# Groundwater Transfer Review Summary Form

Transfer/PA # T- 14721 (RA)

Application: T-14721

Applicant Name: Robert W. Gabriel

**Static Water Levels**

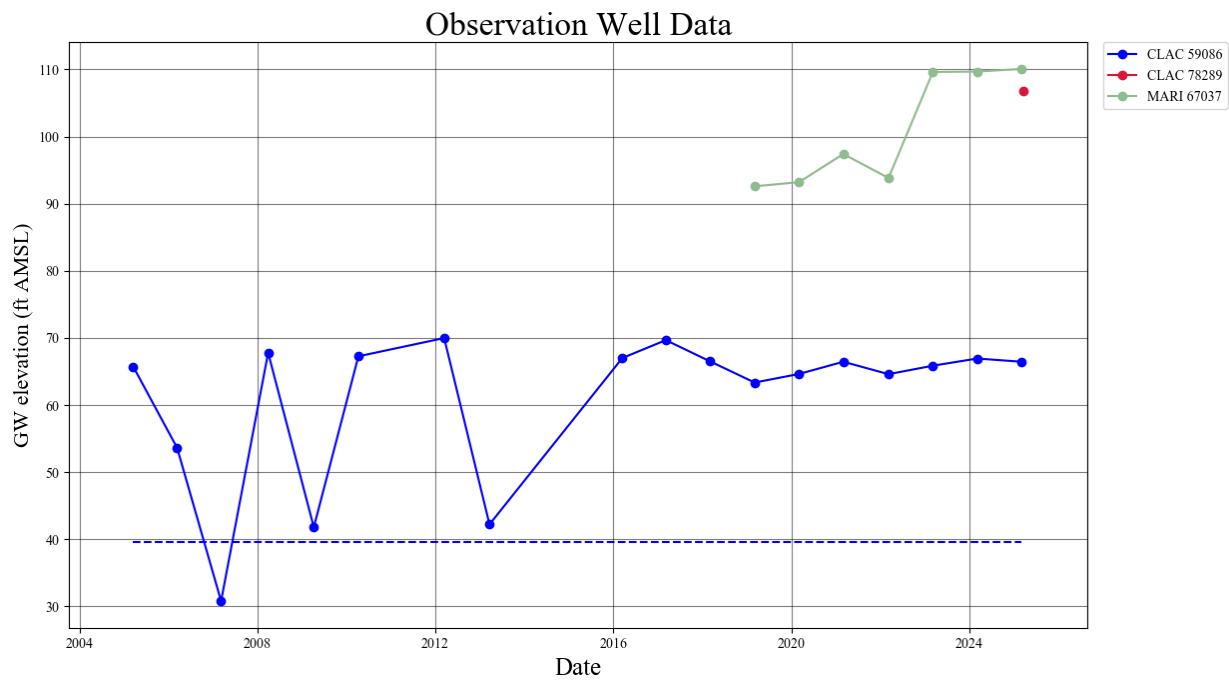
The 3/9/2007 measurement of 148.21 feet blsd reported for Well 5 exceeded the decline condition trigger level of 139.33 feet blsd. All other reported measurements for Well 5 were above the trigger level.

The measured water levels at Well 2 are between ~30 and ~50 feet higher than at Well 5. Based on the hydraulic gradient reported in Woodward et al., 1998, and the difference in water level between Well 2 and Well 5 in March 2019 (29.24 feet), the reference level for Well 2 (MARI 67037) is 66.37 feet blsd (93.80 feet amsl)

Based on the difference in water level between Well 2 and Well 9 in March 2025 (3.33 feet), the reference level for Well 5 is 73.44 feet blsd (90.47 feet amsl).

Interference at CLAC 8543 (Certificate 80410) while pumping the proposed max rate at Well 2 (1.929 cfs).

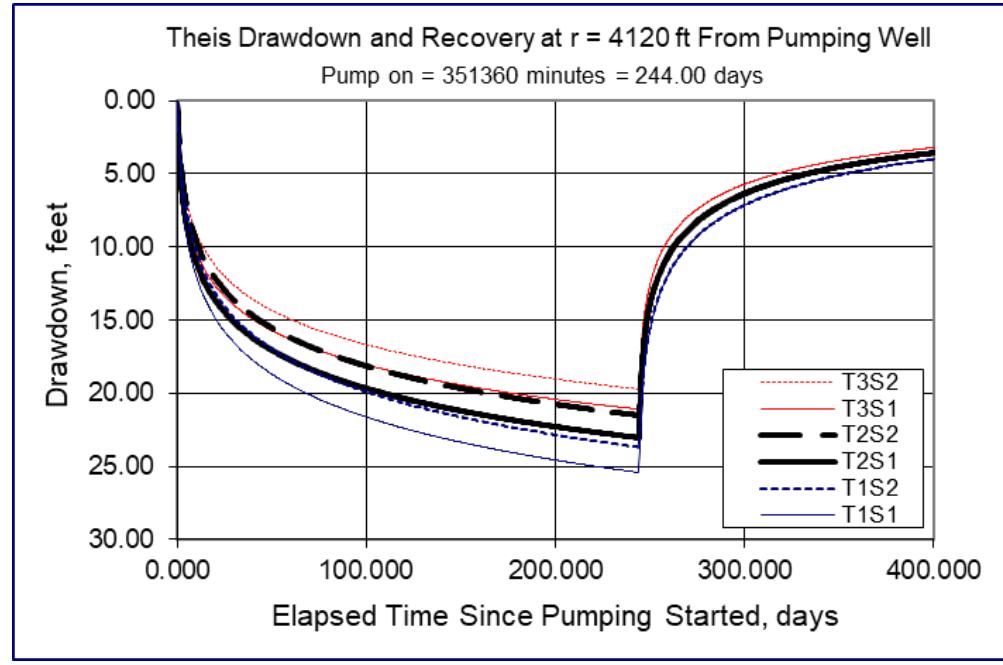
The total interference at CLAC 8543 (Certificate 80410) from pumping the maximum proposed rate of 1.929 cfs at Well 2 is 25 to 33 feet of drawdown. This results in a net increase of 0.5 to 2 feet of interference at CLAC 8543. See **Theis Interference Drawdown Analysis**.

- b) If yes, would this proposed change, at its maximum allowed rate of use, likely result in another groundwater right not receiving the water to which it is legally entitled?  
 Yes  No If yes, explain: Certificate 80410 allows CLAC 8543 to pump at 0.07 cfs, resulting in <5 feet of modeled drawdown at CLAC 8543. Based on the 108 feet of water column at CLAC 8543, the total interference of 25-33 feet while pumping the maximum proposed rate at Well 2 still allows Certificate 80410 to receive the water to which it is legally entitled.
